Run 2b TDC Review Committee Report

Run 2b TDC Review Committee

A review of the Run 2b TDC project was held on September 28, 2004. The Charge to the Committee is included as Appendix A. Primarily, the Committee was asked to provide a recommendation on whether or not to proceed with the production order of the Run 2b (“Chicago”) TDC. In evaluating this question, there are three fundamental issues:

Figure 1. Readout deadtime versus readout rate for the Run 2a TDCs. The readout time is limited by DSP processing time when SL1-4 are pulsed, and limited by readout time when SL1-8 are pulsed. The green curve best mimics the peak luminosity conditions of Run 2b.

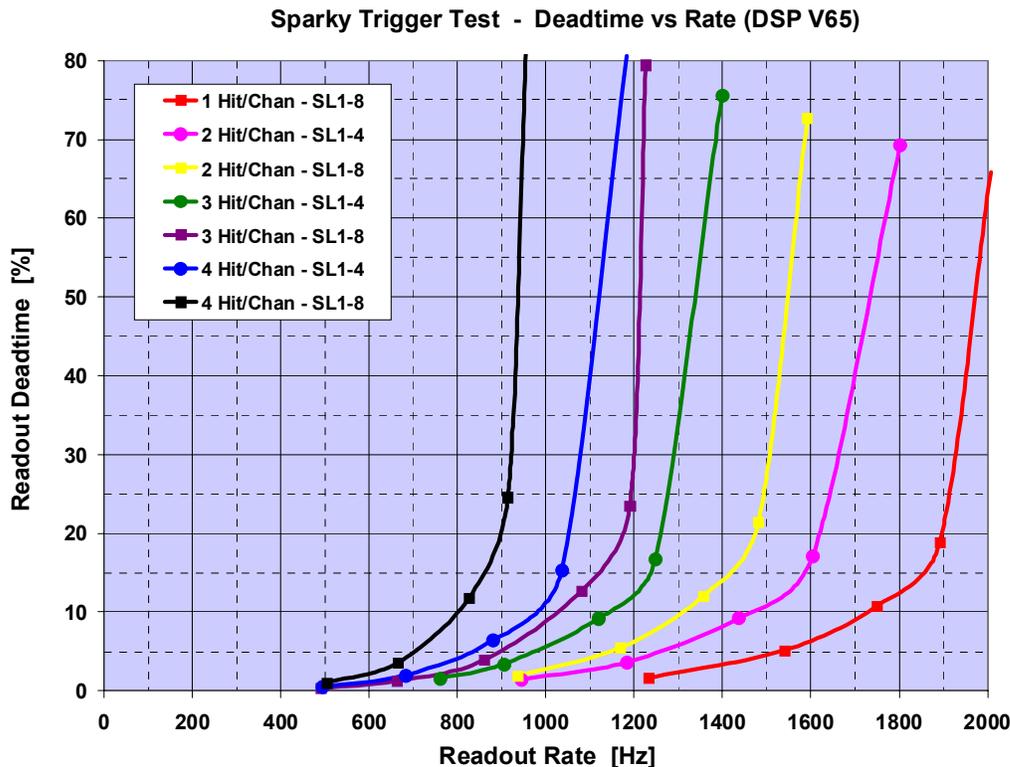
Recent performance measures for the Run 2a system indicate that, at high luminosity, the system will be limited by the DSP processing time and not the readout rate. To insure that out of time hits do not become a limitation, it is proposed to implement the “fast clear” option on the SL 5 and 6 TDCs. [As mentioned earlier, this option is already in place in the Rev. F TDCs which instrument SLs 1-4.] The benchmark tests using COT ASD hit pulsing with the “Sparky” phototube trigger indicate that a 1kHz readout rate can be achieved with 5% deadtime. This is seen as the green curve in Figure 1.

- Thanks to the improved performance of the DSP code, the implementation of the “fast clear”, the implementation of the Run 2b data format, and an improved understanding of the COT performance at high luminosity, the Run 2a TDCs will satisfy the Run 2b specification.
- The estimated peak readout rate shown here (1kHz) is a factor of 7 better than 2002 projection of 150 Hz peak readout rate.
- It will be necessary to implement the “fast clear” in SL5 and SL6 TDCs.

- DSP version 65, which includes the new TDC data format, should be implemented as soon as possible. We recommend that it become default for operations by January 2005.

- CDF should immediately begin modifying spare TDC boards with the fast clear option. The installation of modified boards can be staged, but it is important to understand the scope, timescale and success rate of this modification.
